Proposal #15: 1053-07-61
Wausau - Wittenberg
CTH Q to Bass Lake Road, WB
STH 29
Marathon County

This is Addendum No. 02, which provides for the following:

ADDENDUM NO. 02

1053-07-61

Addendum No. 02
ID 1053-07-61
Revised Sheet 16
August 7, 2025

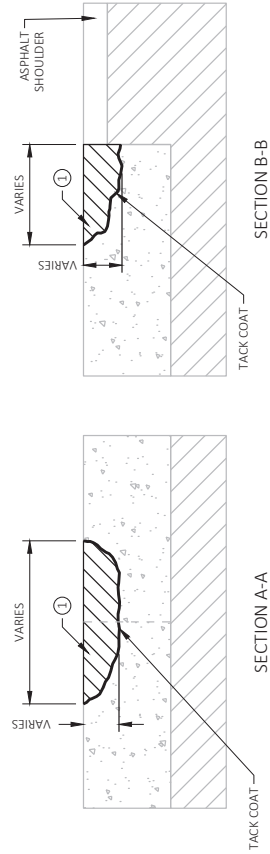
Revised Plan Sheets	
Plan Sheet	Plan Sheet Title (brief description of changes to sheet)
16	Construction Details (revised detail sub-title)
68	Miscellaneous Quantities (switched bid item for Concrete Joint and Crack Cleaning and Repair)

- ① REMOVE LOOSE OR SPALLED CONCRETE AND ASPHALT PATCHING
 - ② EXISTING CONCRETE SHOULDER 6-FOOT OR LESS INCLUDED IN REPAIR AREA OF ADJACENT LANE
- ASPHALTIC SURFACE
EXISTING CONCRETE PAVEMENT
EXISTING BASE COURSE

CONCRETE JOINT AND CRACK CLEANING AND REPAIR
LOCATIONS AND LIMITS DETERMINED BY THE ENGINEER IN THE FIELD
